# Field Service Information C650 No Camera Function

Our Reference: SI33 6 2004

Product/System: C650

Subject: C650 No Camera Function

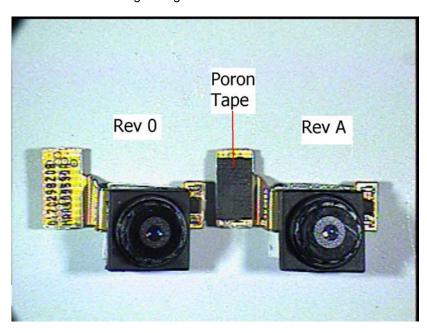
Service has been made aware of a camera issue on the C650 product. The camera module to PCB connector at times will not mate properly, resulting in an intermittent or no camera operation when attempting to capture a photo.

A redesigned camera module has been implemented in production units. The part number 0170298Z08 changes from a Rev 0 to Rev A. This Rev A module has two modifications from the original design:

1) A poron tape has been added to the top of the module to PCB connector. Refer to the photo below to aid in distinguishing between the Rev 0 and Rev A camera modules:

2) In addition, the soft poron tape under the module has been changed to hard acrylic.

- 1) Disassemble the unit to gain access to the camera module;
- 2) Verify that the module has the poron tape installed on the camera flex as shown in the above photo. Replace with a Rev A module if necessary.
- 3) Reassemble the unit and test camera operation.
